SUBJECT: VERMONT YANKEE NUCLEAR POWER STATION - ISSUANCE OF
AMENDMENT RE: REVISED REACTOR VESSEL PRESSURE-
TEMPERATURE LIMITATION CURVES (TAC NO. ME5252)

Amendment No. 250
License No. DPR-28

SAFETY EVALUATION BY THE OFFICE OF NUCLEAR REACTOR REGULATION

Figure 3.6.1

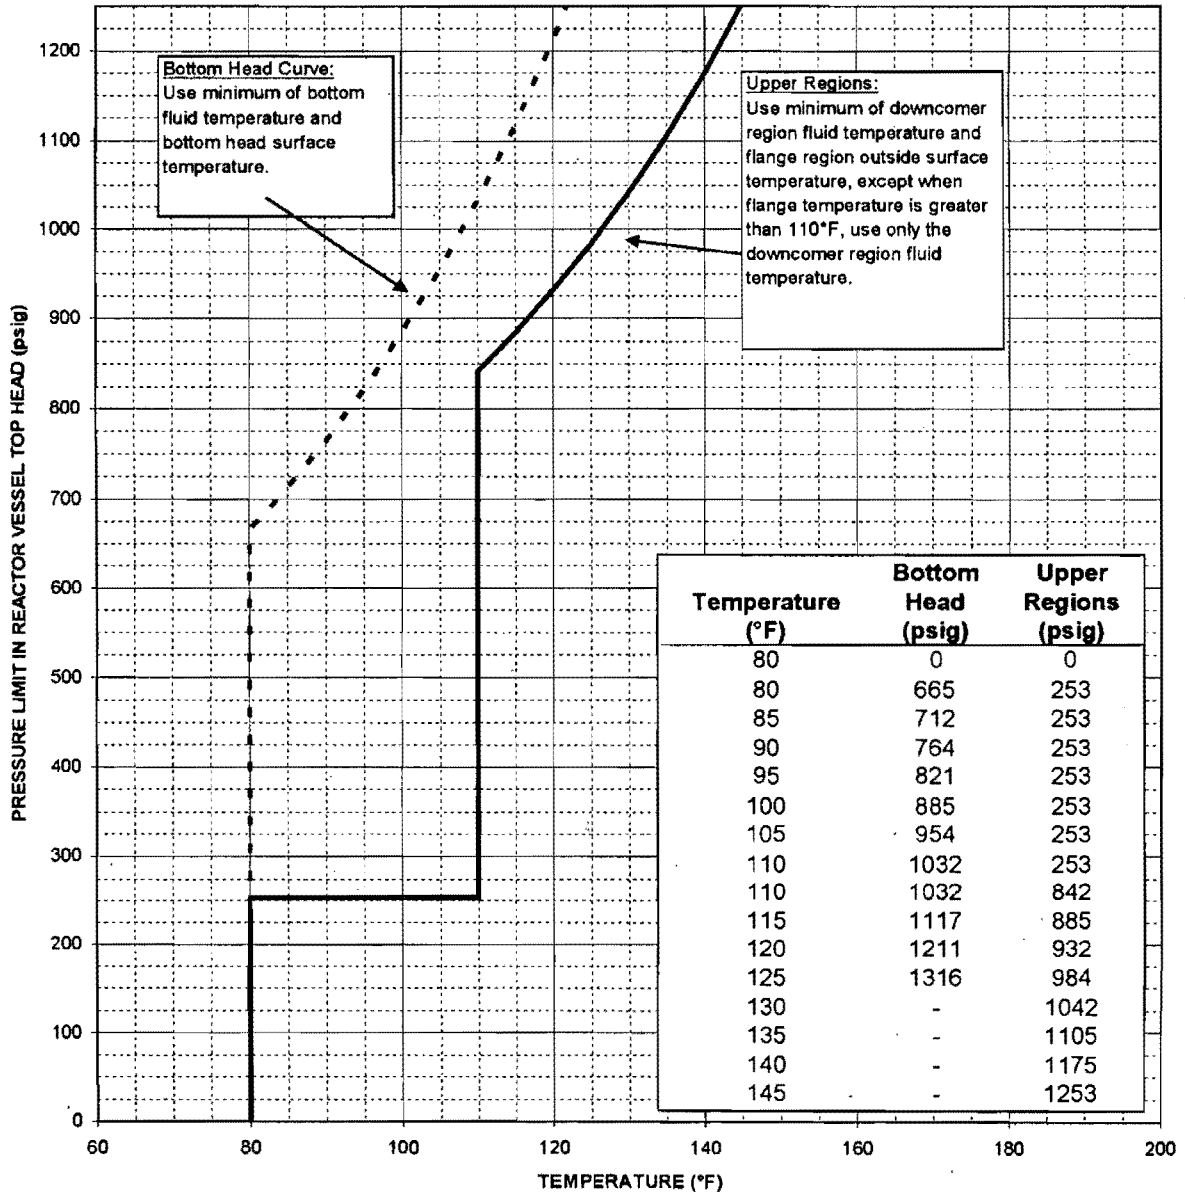
**40°F/hr Heatup/Cooldown Limit
Valid Through 7.943'E8 MWH(t)**

The licensee proposes updating the bounding run-time to 7.943×10^8 MWH(t), corresponding to a bounding 1/4T neutron fluence of 1.24×10^{18} n/cm², while the licensee predicts that the RPV will only reach a 1/4T neutron fluence of 5.39×10^{17} n/cm² by the end of a 20-year license renewal (LR) period (for a total of 60 years of licensed operation). This update would support operations into the LR period beyond the original 40-year operating license.

Figure 3.6.3

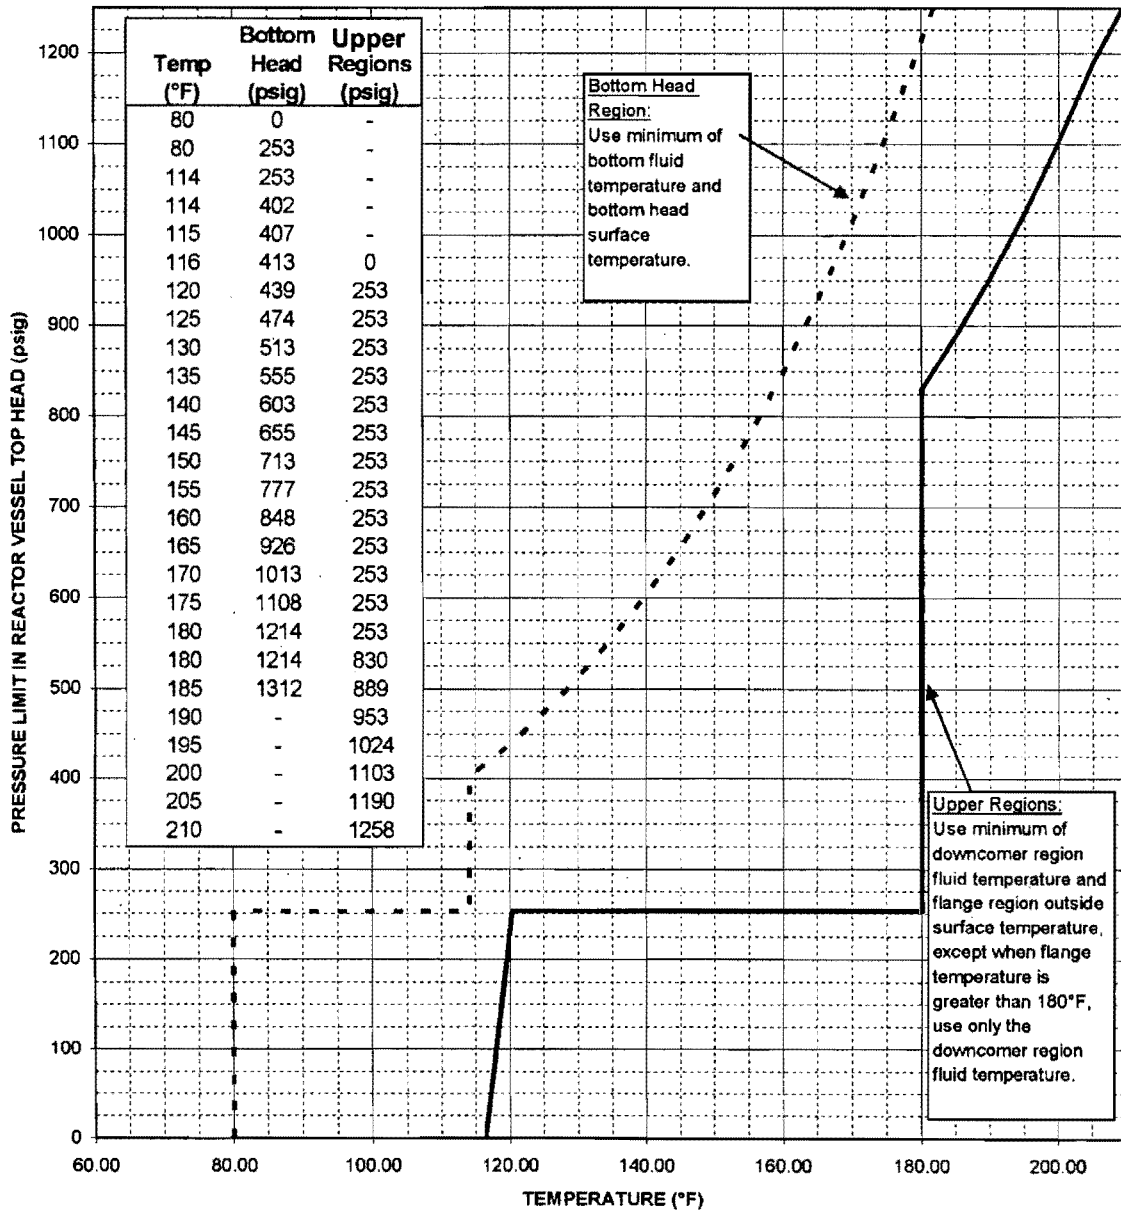
**100°F/hr Heatup/Cooldown Limit
If Pressure < 253 psig, Water Level must be within
Normal Range for Power Operation
Valid Through 7.943 E8 MWH(t)**
